**Responses to Questions and Comments for Which the I-495 Express Lanes Northern Extension (495 NEXT) Project Team Indicated Complementary Responses Would be Provided
495 NEXT May 26, 2022 Meeting Related to Live Oak Drive Design Plans**

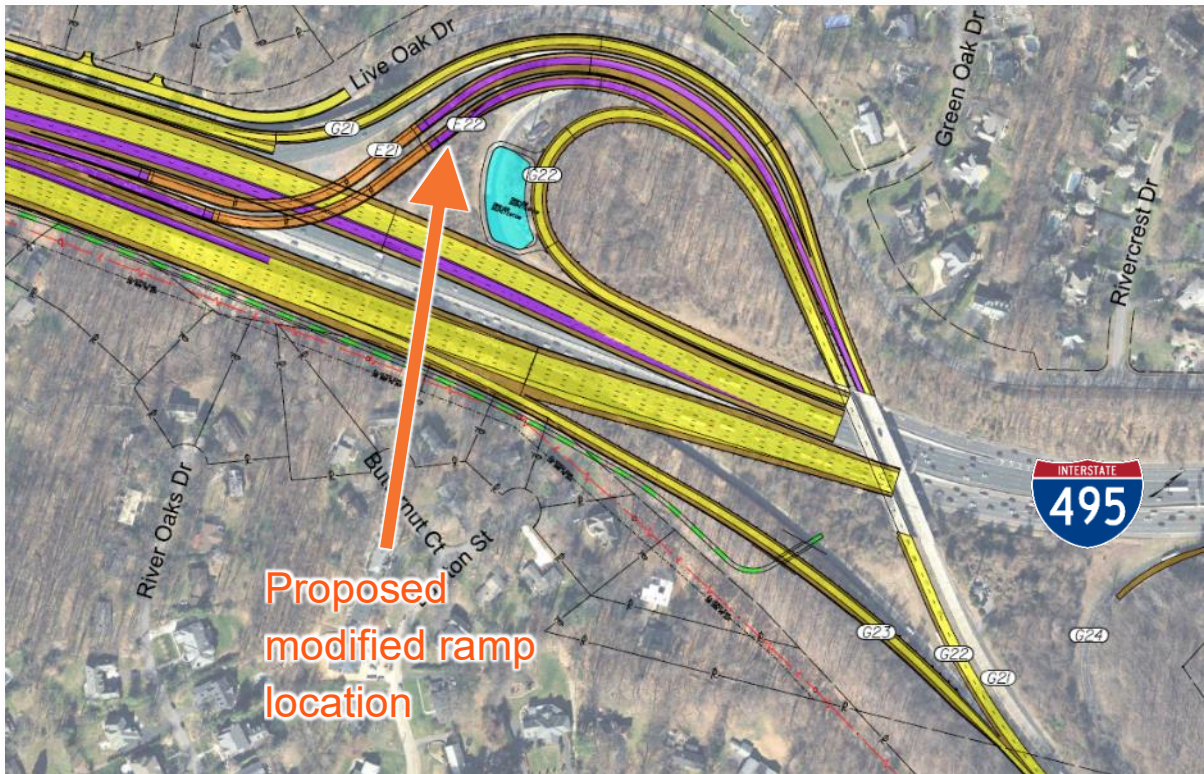
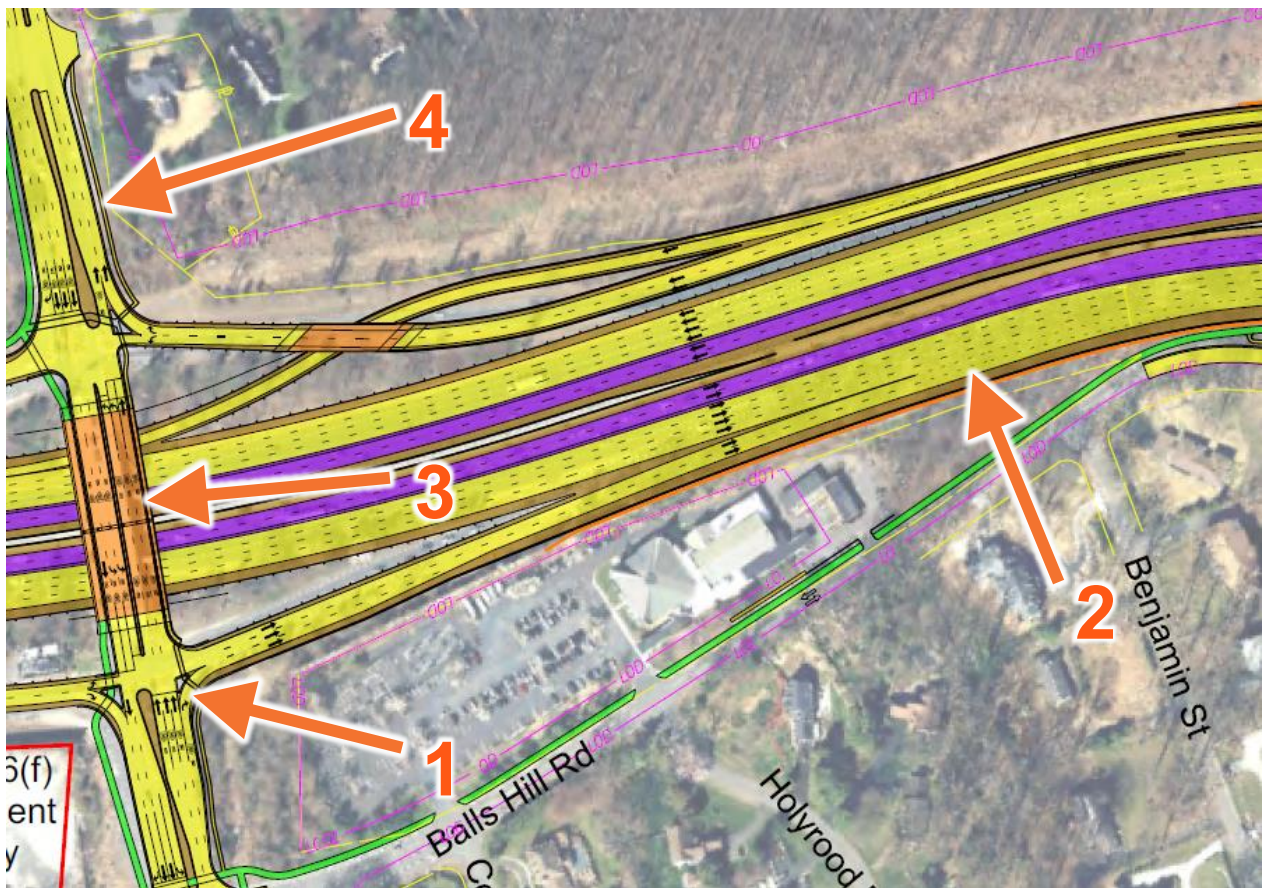
11. What was the process by which VDOT came to the ramp modification at the George Washington Parkway interchange in the vicinity of Live Oak Drive?

- Re-alignment of the off-ramp from northbound I-495 express lanes to the George Washington Memorial Parkway (GW Parkway).
 - Previous Configuration: The northbound express lanes exit ramp was originally proposed to fly over the northbound I-495 general purpose lanes and tie into the GW Parkway east of I-495, just west of the National Park Service (NPS) property boundary, as shown in the exhibit below.

- Current Proposed Configuration:** The northbound express lanes exit ramp is now proposed to fly over the southbound I-495 express lanes and general purpose lanes and follow inside the alignment of the previously-proposed on-ramp from eastbound GW Parkway to the southbound I-495 express lanes. This configuration is referred as the “nested loop ramp” configuration. The proposed ramp will merge with off-ramp from the southbound I-495 general purpose lanes to GW Parkway and then cross all lanes of I-495 to enter the GW Parkway. The modified configuration, as shared in the September 29, 2021 Public Information Meeting, is shown below.

- Re-alignment of the off-ramp from northbound I-495 general purpose lanes to GW Parkway, to tie into the existing ramp closer to I-495.
- Re-alignment of the off-ramp southbound I-495 general purpose lanes to GW Parkway, to shift the physical gore point further north and to merge with the newly proposed northbound I-495 express lanes nested off-ramp.
